September 13, 2021

Pearl High School Indoor Training Facility
Pearl, Mississippi

ADDENDUM NO. 03

E2.2
PARTIAL POWER
PLAN - PART B

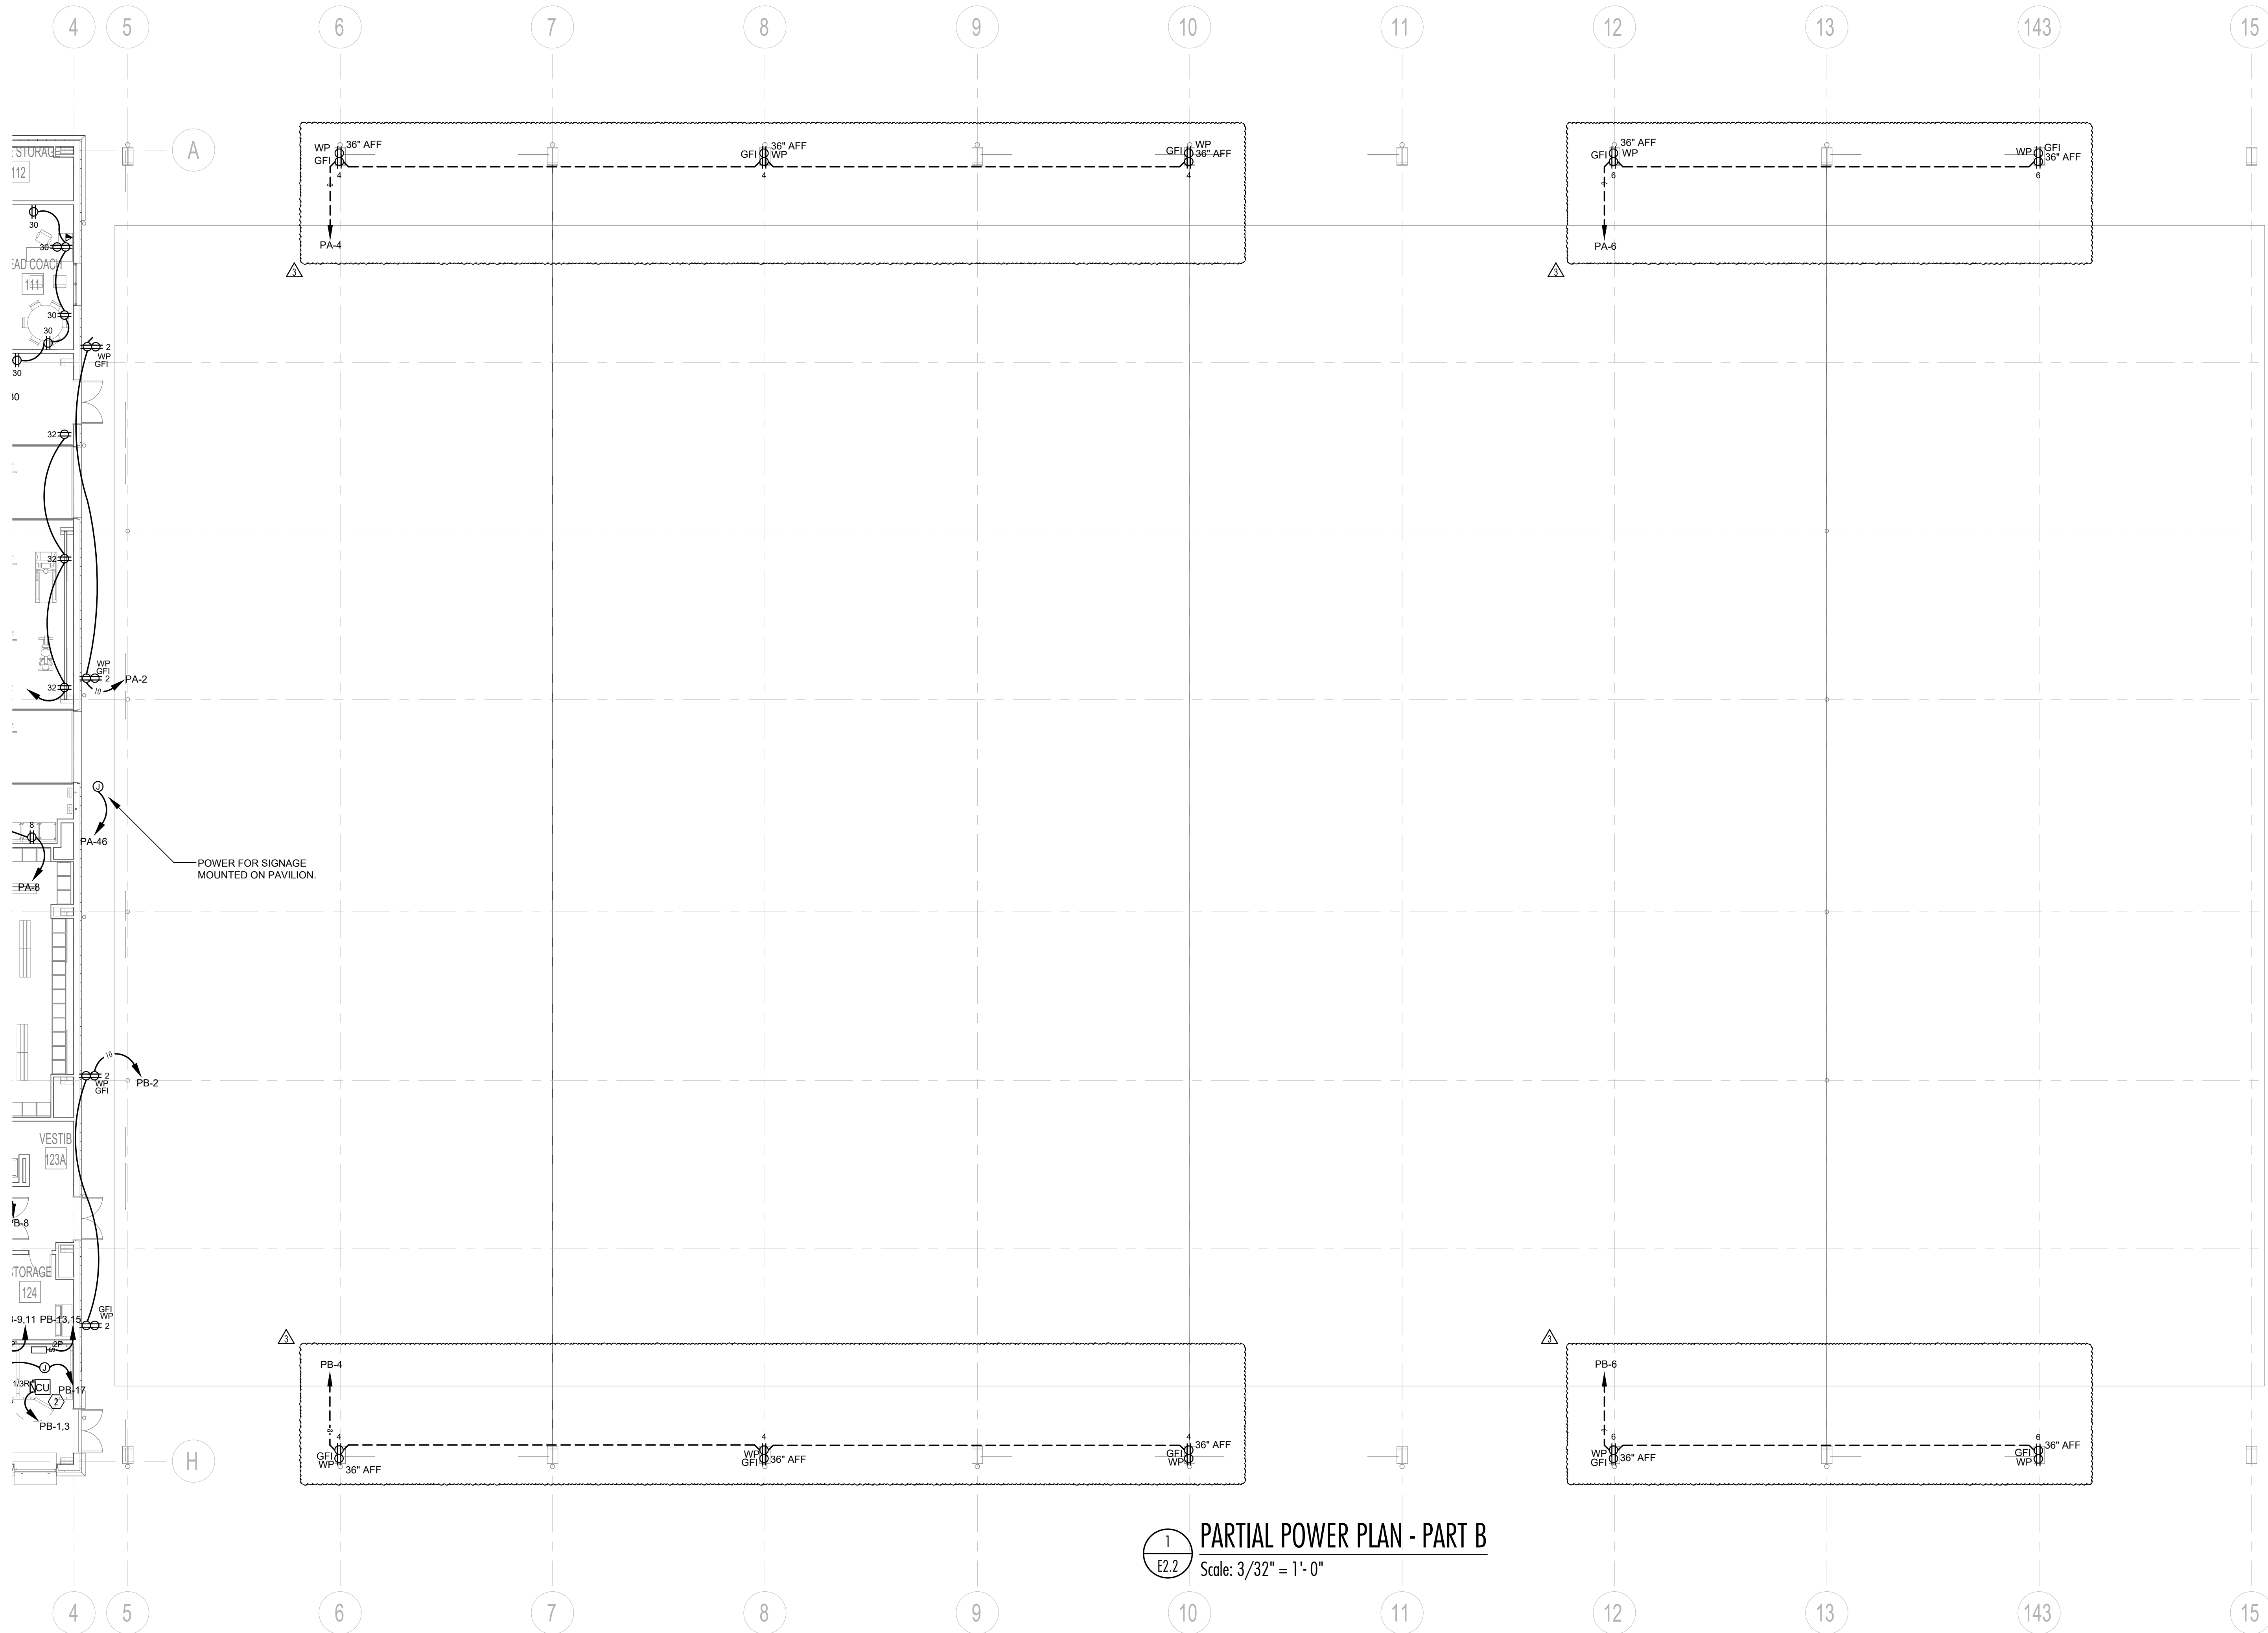
- ITEM NO. 09 E1.2 PARTIAL LIGHTING PLAN – PART B**
E2.2 PARTIAL POWER PLAN – PART B
Revise per the enclosed sheets
